CITY OF ALBUQUERQUE

RE: **Lot 7 Block 1 Volcano Cliffs SAD 227**
6209 Papagayo NW
Grading and Drainage Plan
Engineers Stamp Date 9/25/17 (D10D003B26)

RE: **Lot 26 Block 6 Unit 22 Volcano Cliffs SAD 228**
6209 Papagayo NW
Grading and Drainage Plan
Engineers Stamp Date 9/25/17 (D10D003B26)

DRAINAGE AND TRANSPORTATION INFORMATION SHEET (REV 09/2015)

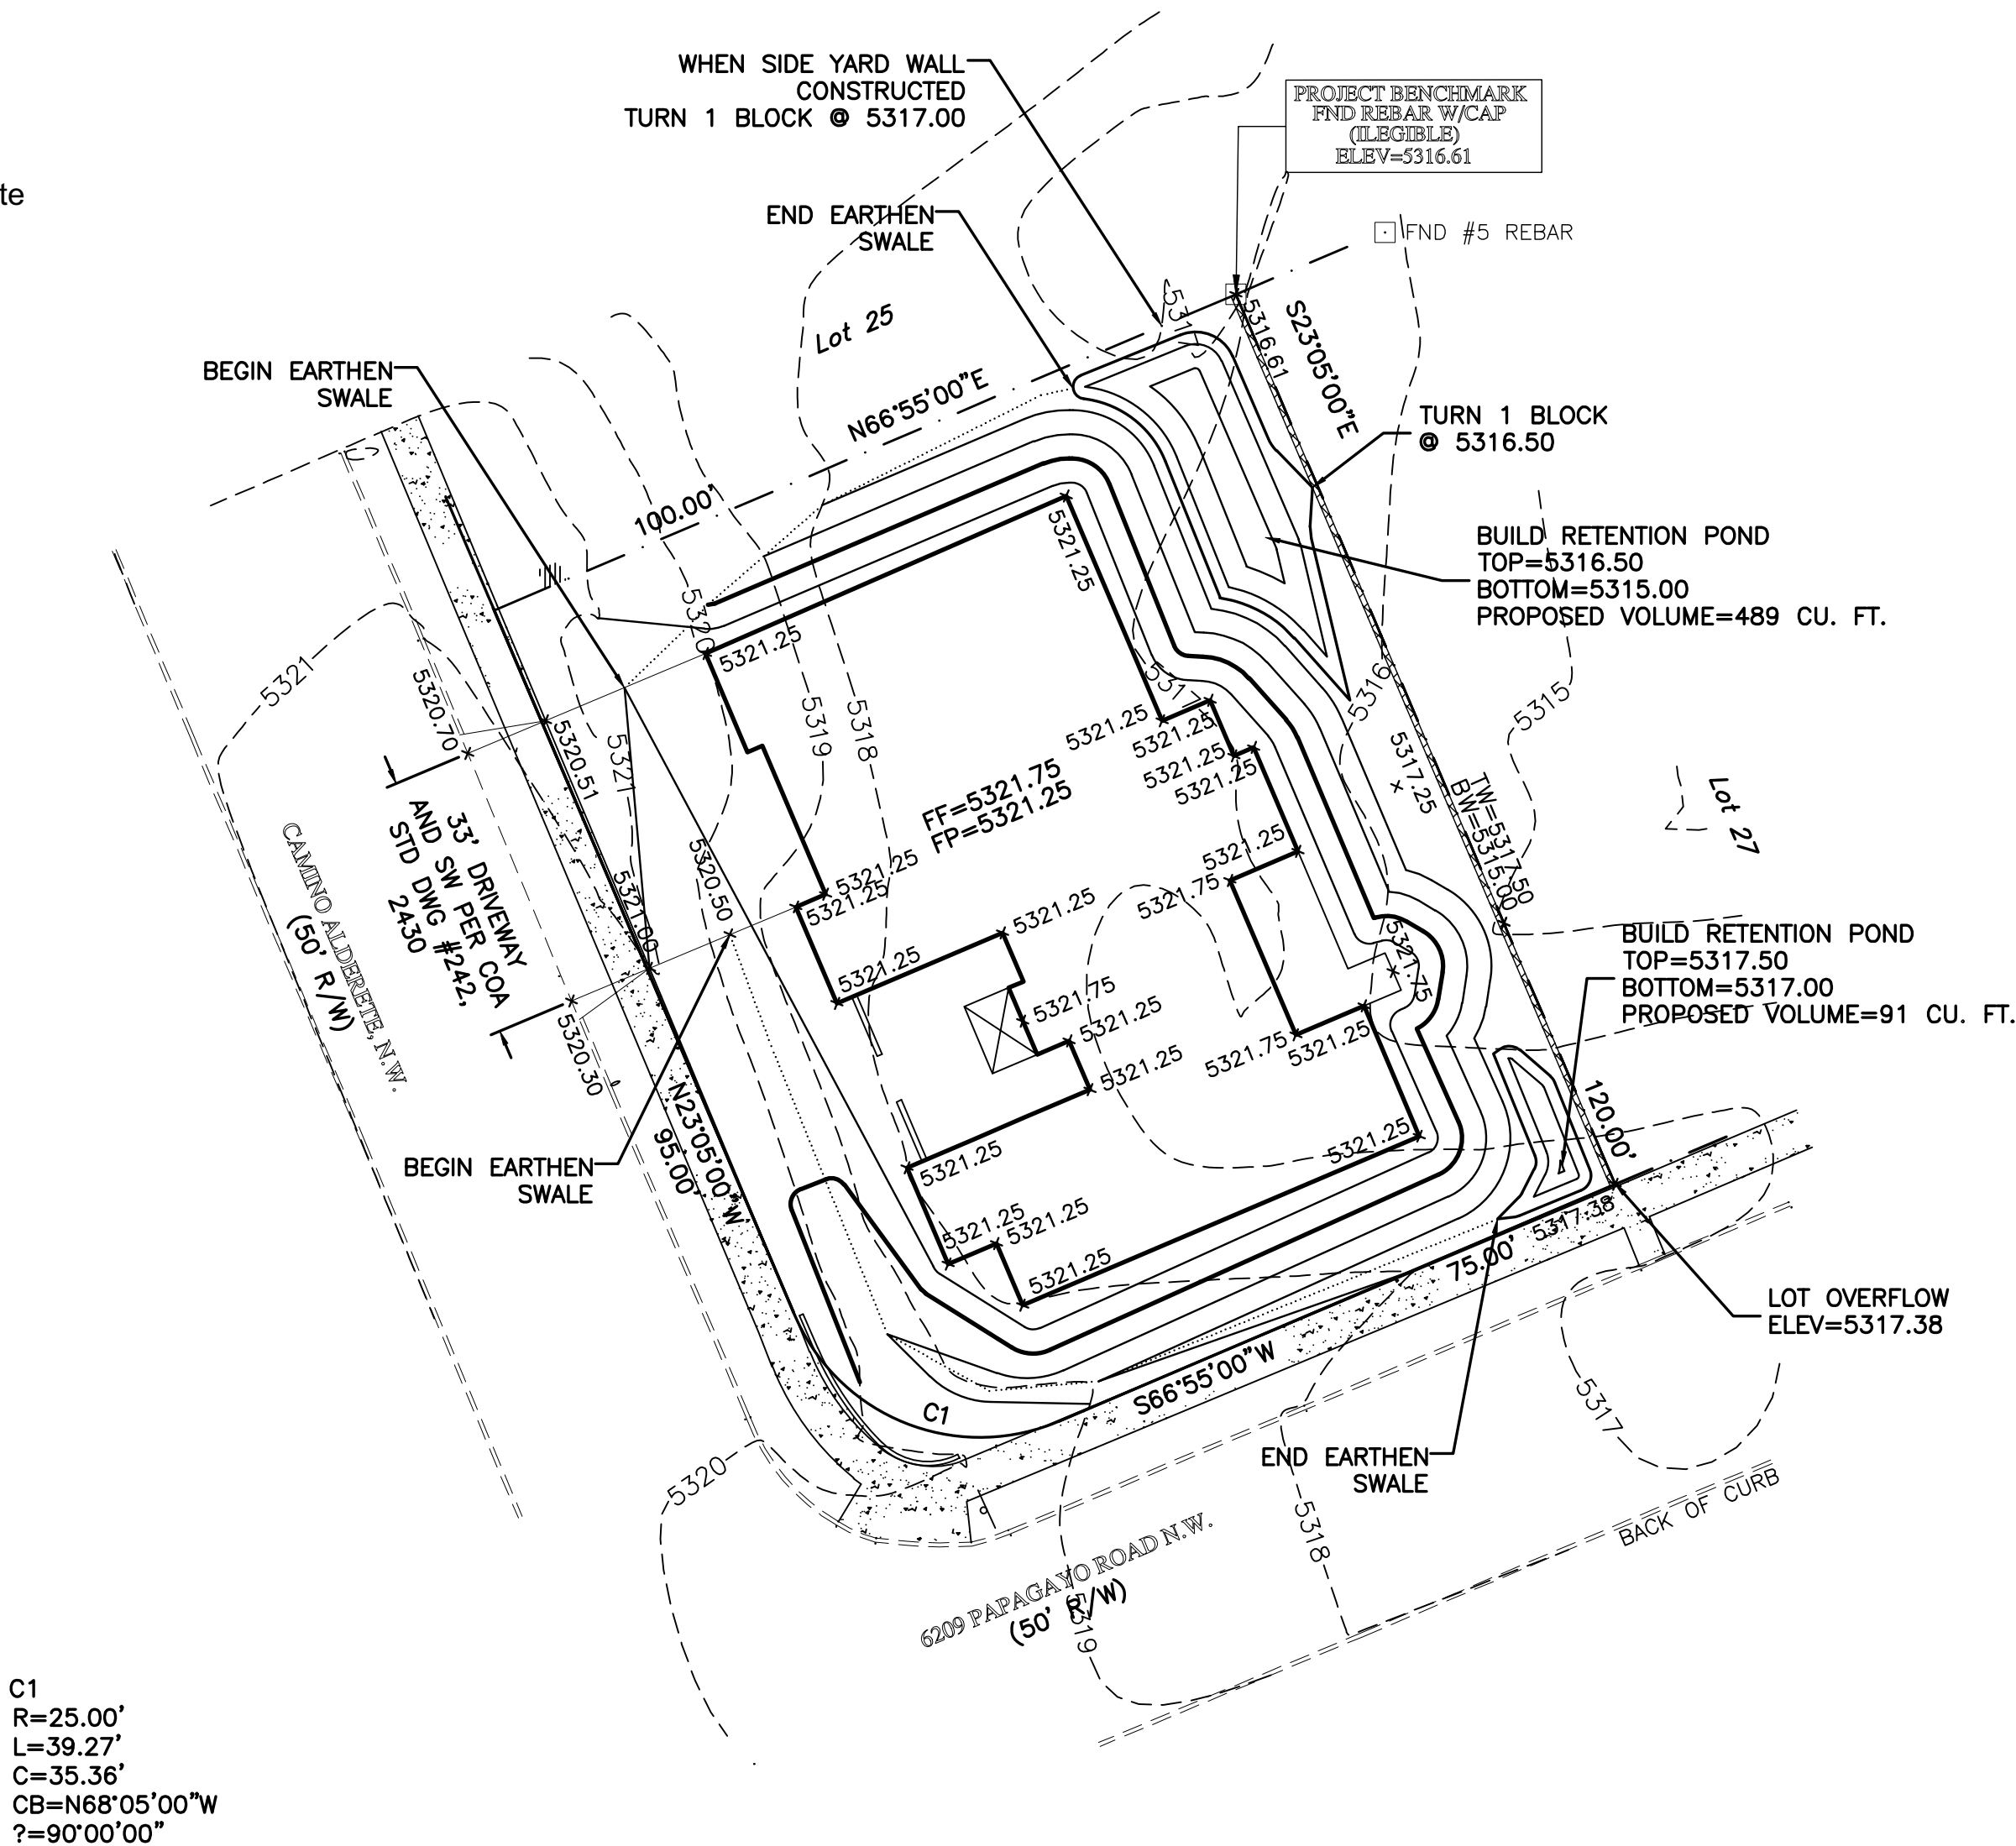
Based upon the information provided in your submittal received 9/26/17, this plan cannot be approved for Grading Permit until the following comments are addressed.

- Show the 7 foot P.U.E. in the North and East of the property.
- Provide size of openings and calculations required in future garden walls.
